**ADDENDUM NO. 1**  
**June 21, 2021**

Mina Lake Spillway Replacement  
Mina Lake  
Edmunds County, South Dakota  
GFP Project No. Mina22Pa

Scope of this Addendum:

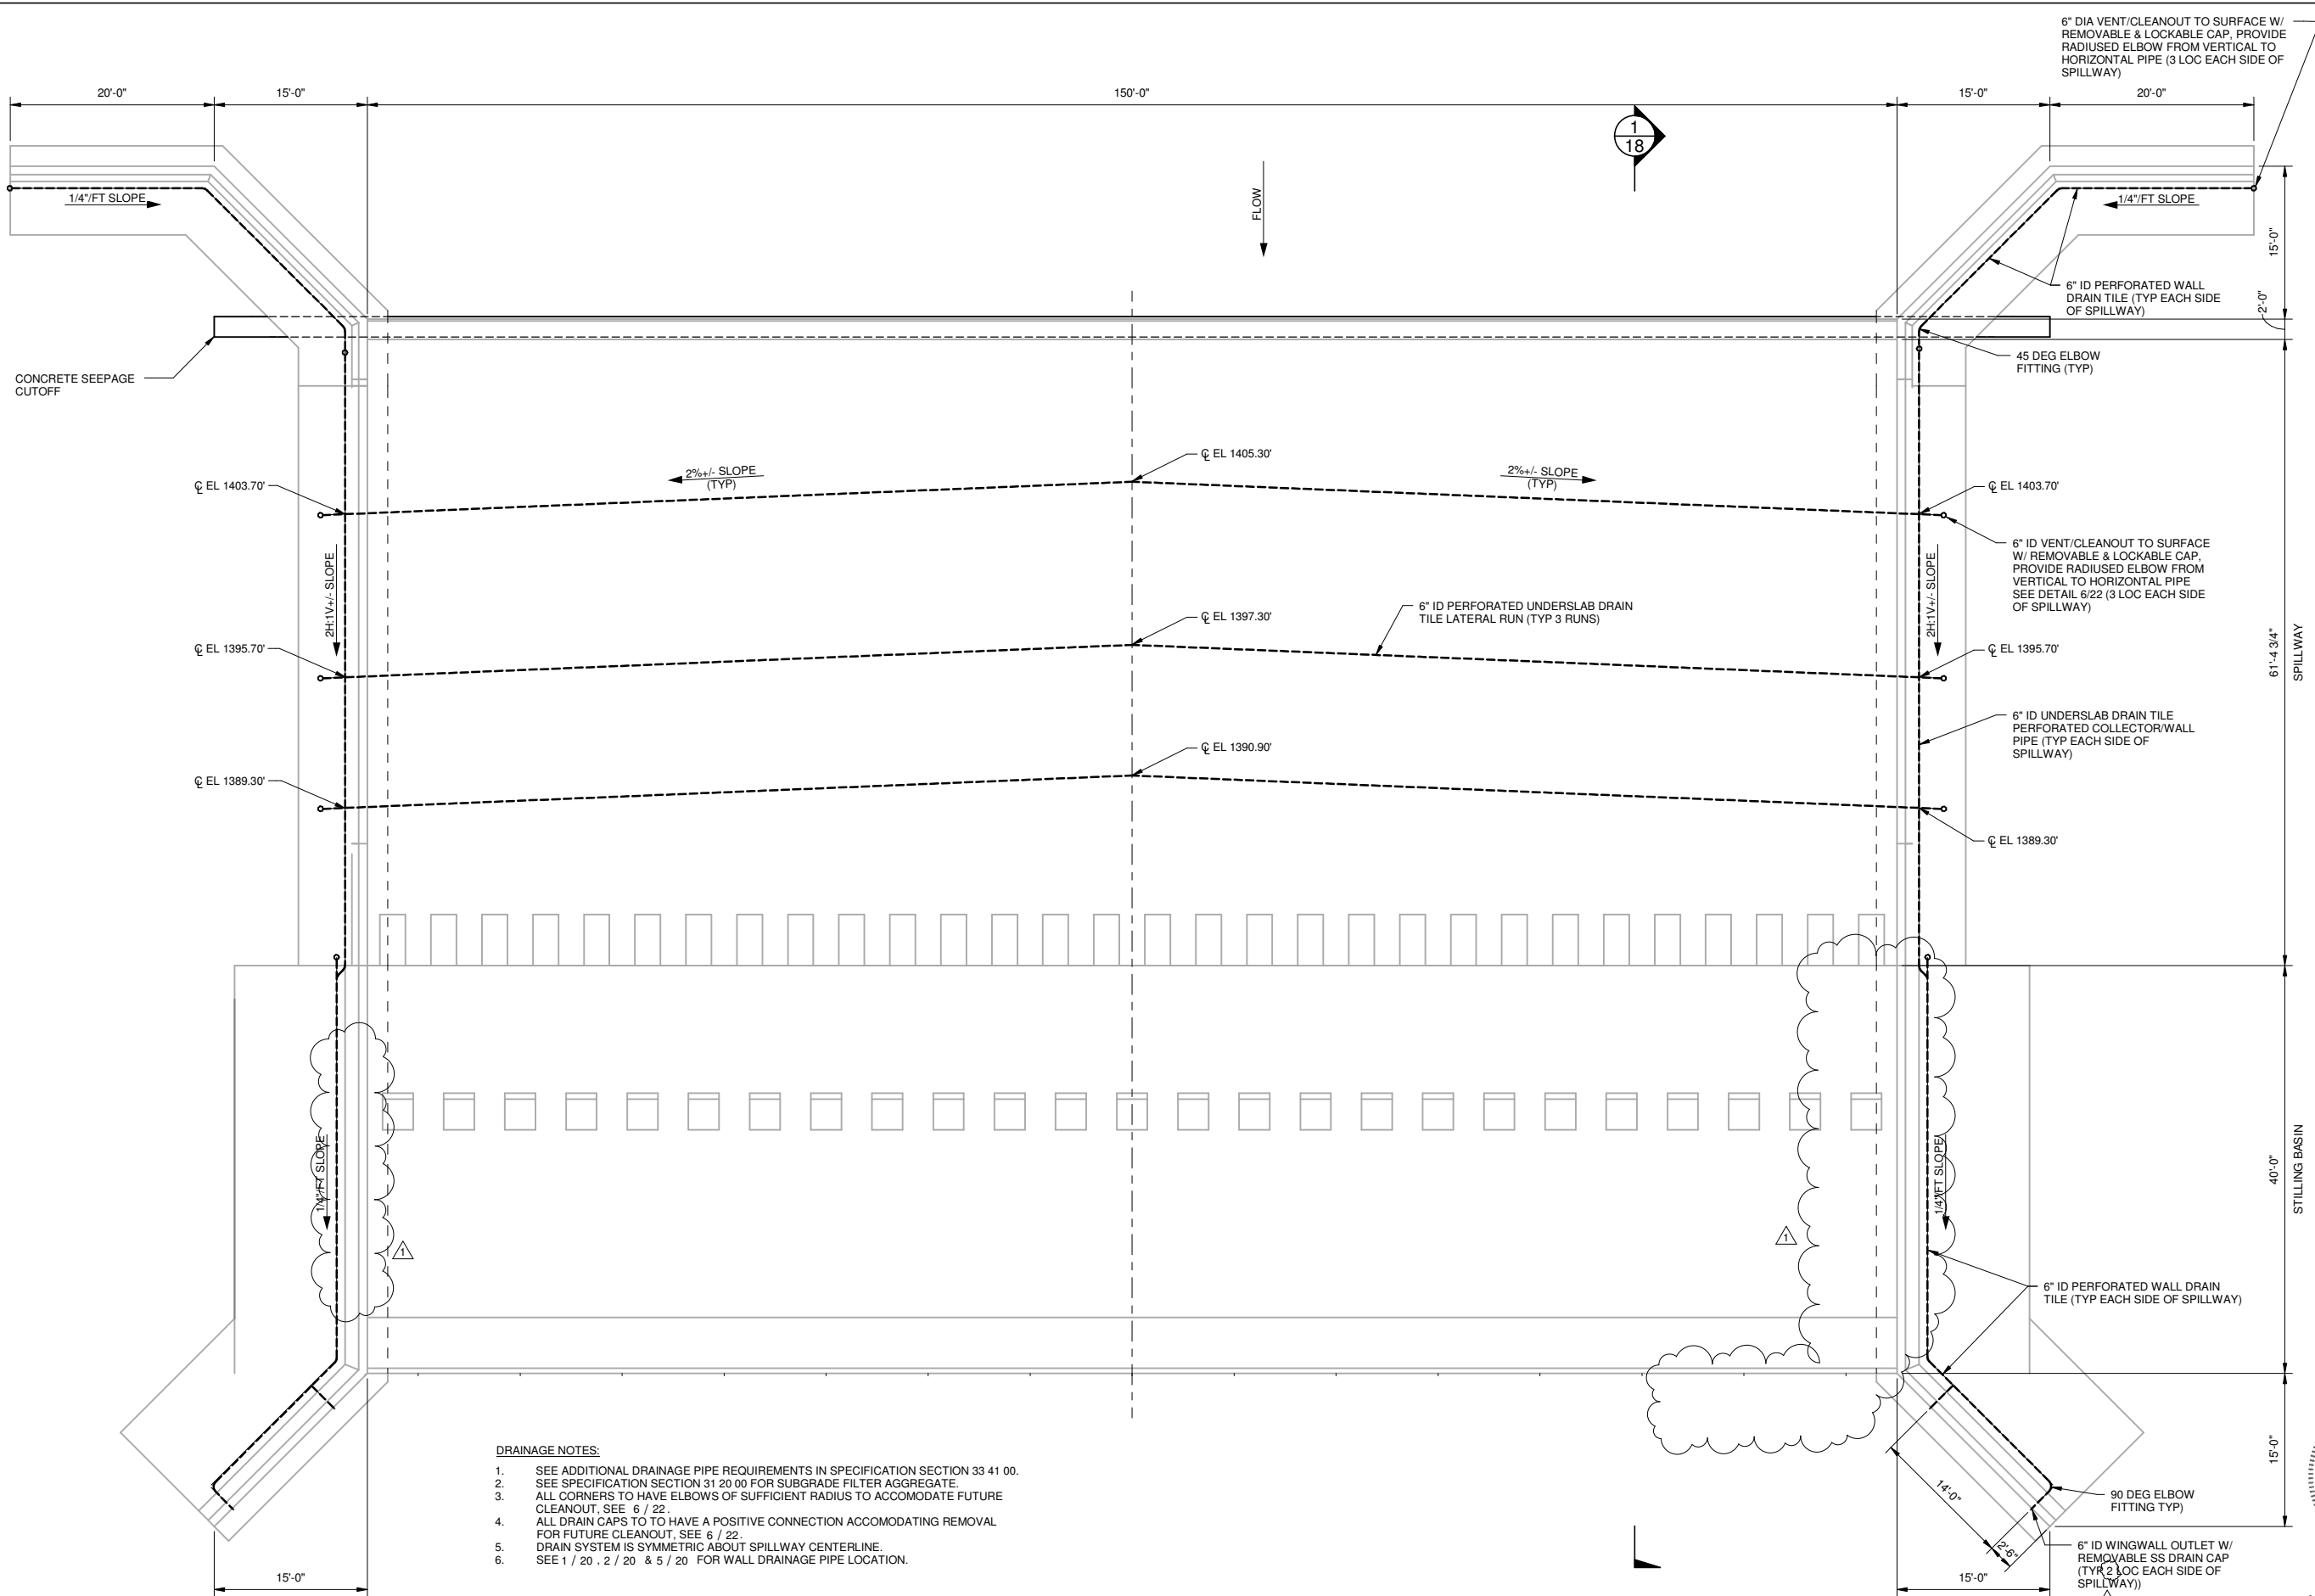
Item No. 2: Construction Plans Correction: Removed a total of six wall drain outlets with drainage caps in stilling basin; four still remain in downstream wingwalls. See Revision 1 of sheets 17 of 30 and 18 of 30; attached.
